# CITY OF COCONUT CREEK

## DEVELOPMENT REVIEW COMMITTEE (DRC) REVIEW #3 – JULY 1, 2026

<b>PROJECT NAME:</b>	NBPS Art and Innovation Center and Early Childcare Center		
<b>PROJECT NUMBER:</b>	PZ-25110002		
<b>LOCATION:</b>	7600 Lyons Road		
<b>APPLICANT/AGENT:</b>	Miskel Backman, LLP		
<b>REVIEW/APPLICATION:</b>	Site Plan		
<b>STATUS:</b>	Submit for Planning and Zoning Board		
DISCIPLINE	REVIEWER	EMAIL	TELEPHONE
Planning and Zoning	Deandrea Moise, AICP - Planning Manager   DRC Chair	<a href="mailto:dmoise@coconutcreek.net">dmoise@coconutcreek.net</a>	(954) 973-6756
Resilient Design and Development	Liz Aguiar – Assistant Director	<a href="mailto:laguiar@coconutcreek.net">laguiar@coconutcreek.net</a>	(954) 973-6756
Resiliency & Photometrics	Linda Whitman – Resiliency Manager	<a href="mailto:lwhitman@coconutcreek.net">lwhitman@coconutcreek.net</a>	(954) 973-6756
Planning and Zoning	Natacha Josiah - Planner	<a href="mailto:njosiah@coconutcreek.net">njosiah@coconutcreek.net</a>	(954) 973-6756

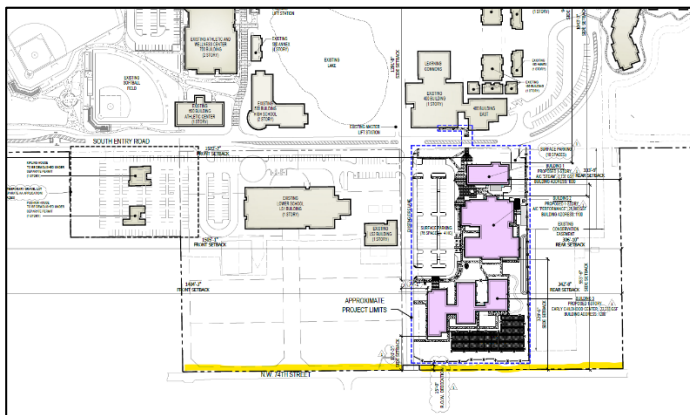
1. Sheet C-301: The southernmost sidewalk abutting the western road intended to serve as a means of egress does not appear to connect to any existing sidewalks or infrastructure that

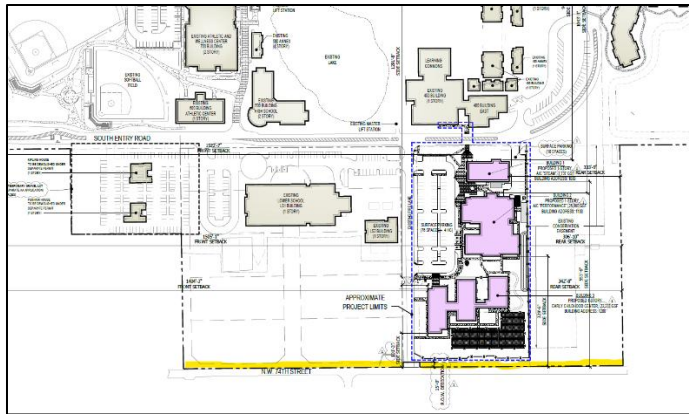
**Comment 3:** Sheet A1.00: The 15 ft right-of-way dedication shown on the sheet does not clearly depict the boundaries of said dedication. The boundaries for the 15 ft ROW dedication should encompass the entirety of the southern property line of the school as shown on BCPA. See the image below for a sketch of requested ROW dedication along 74<sup>th</sup> street (highlighted in yellow).

*Answer: Hatch added to graphically depict boundaries of 15 ft ROW dedication. See updated sheet A1.00 Pursuant to discussions with City staff, the area along NW 74<sup>th</sup> Street lying west of the internal fire access road will be dedicated to the City subject to the existing Conservation Easement.*
